ST75C520 REVISION 1.4

I - INTRODUCTION

The purpose of this document is helping the customer to use the Revision 1.4 of the ST75C520. So the ST75C520 Revision 1.4 Application Guide answers some questions as :

Figure 1 : Detailed Timing Diagram

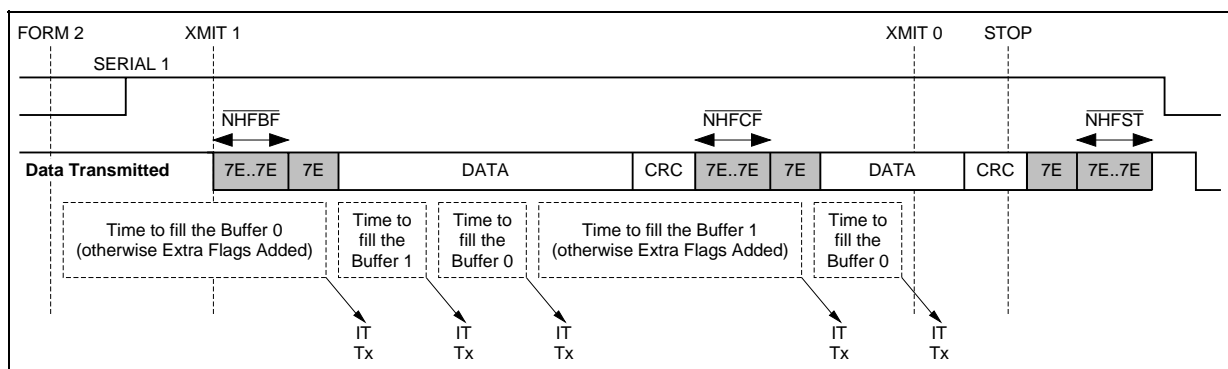
Three new global variables have been added in the Revision 1.3 to allow the programming of new 7E flags before the first frame, between the data frames and after the last frame :

- `_NHFBF`: Number of flags before the first frame.
- `_NHFCF`: Number of flags between frames.
- `_NHFST`: Number of flags after the last frame.

The default value for these three variables is 0. The programming range is from 0 to 7FFF (32767) (see Figure 1).

Figure 3 : D

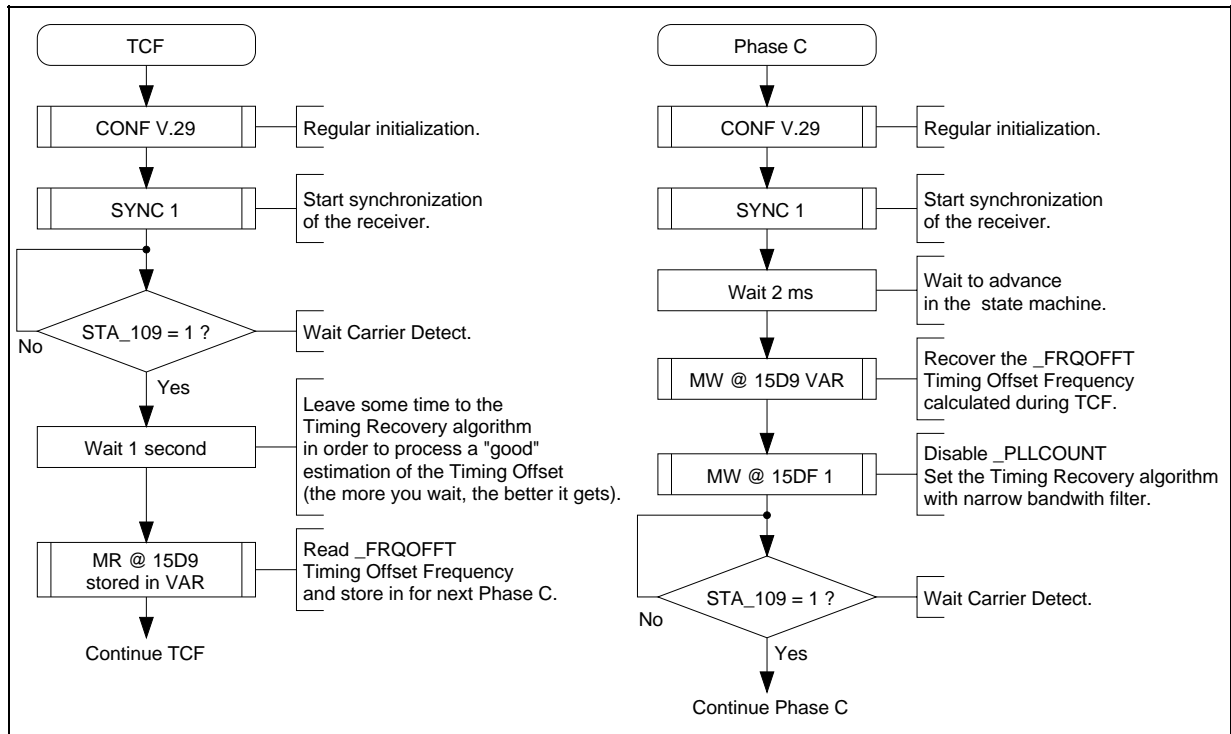
The sequence is described in the following flow chart.
